August 11, 2010

Subject: Addendum to Design Plan, CQA Plan & Technical Specifications  
Nursery Products Hawes Composting Facility  
San Bernardino County, California

JAMES COMPOSTING FACILITY  
 SAN BERNARDINO COUNTY, CA  
**GRADING PLAN**

# **HYDROLOGY STUDY FOR THE 1,000-YEAR FLOOD EVENT**

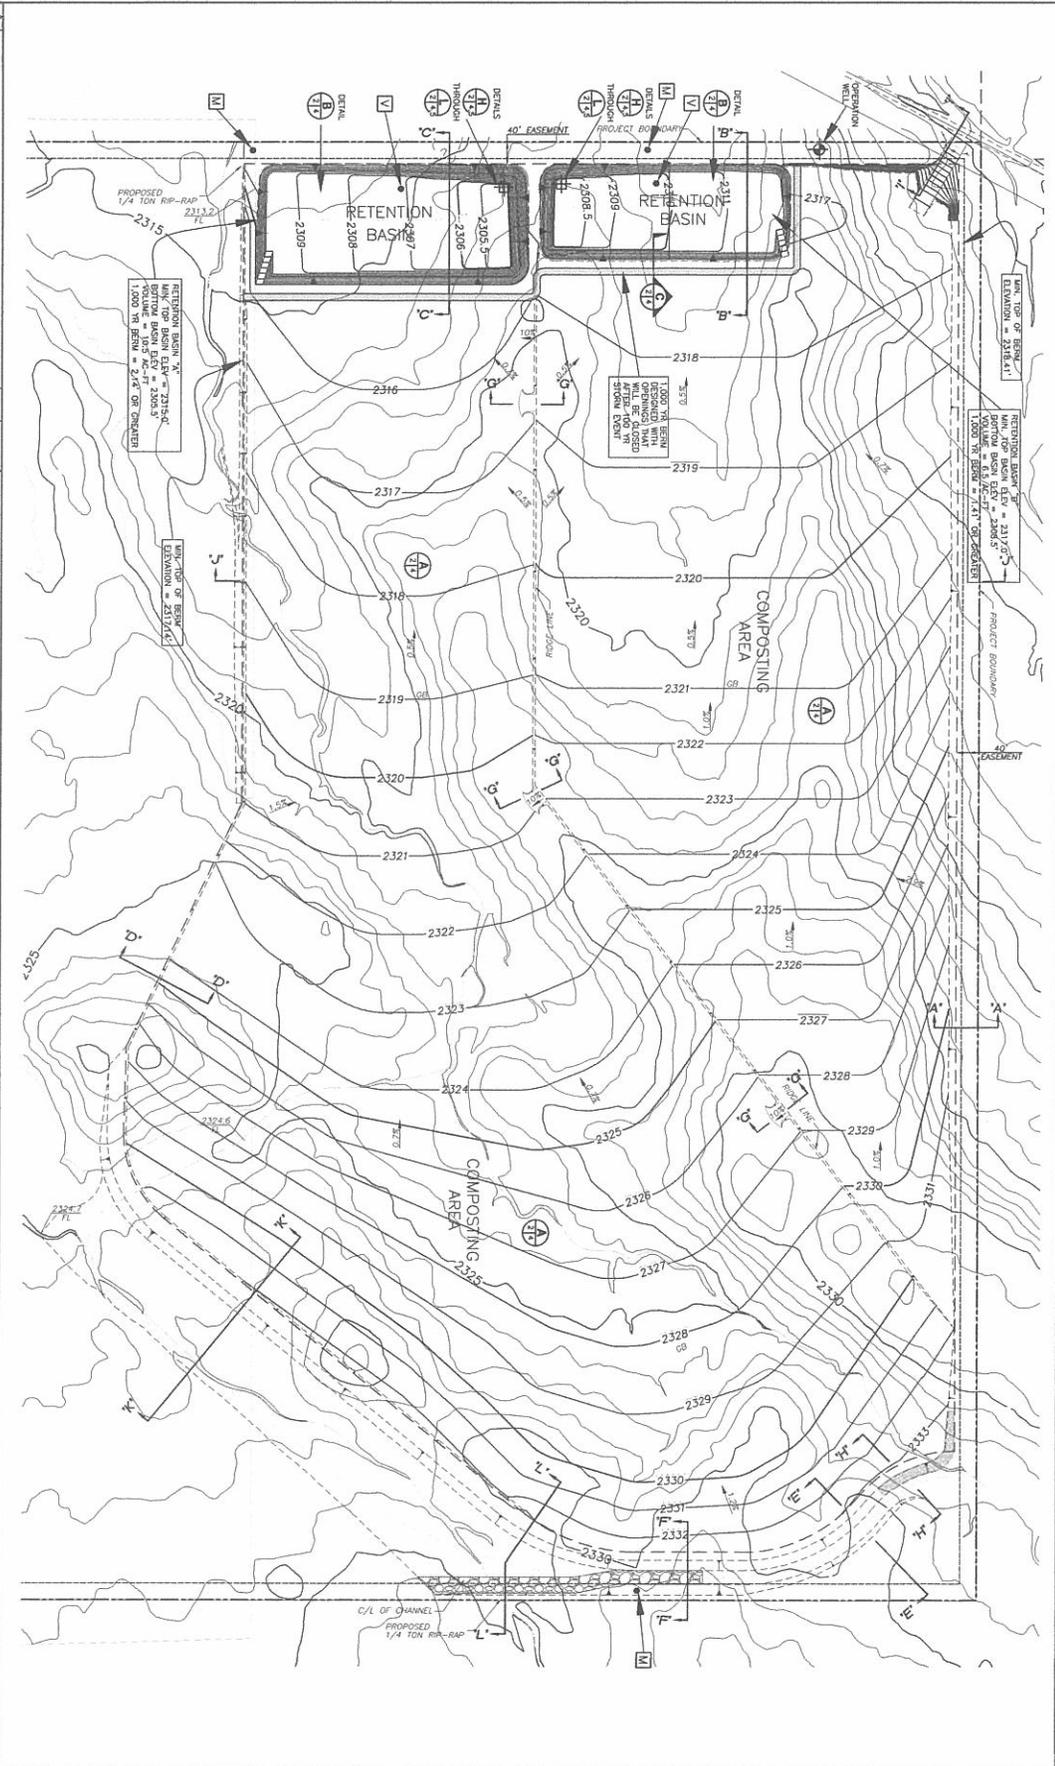
Nursery Products is pleased to submit this letter addendum to the Design Plan, CQA Plan & Technical Specifications (Plan) for the Hawes Composting Facility (Facility) in San Bernardino County, California. This addendum supplements and supersedes the Plan prepared by Nursery Products dated May 5, 2010. This addendum has been prepared for submittal to the Lahontan Regional Water Quality Control Board (RWQCB) and includes the revised pages as attachments.

Enclosures: Revised Plan – Section 3  
Revised Drawing  
Revised Hydrology Report
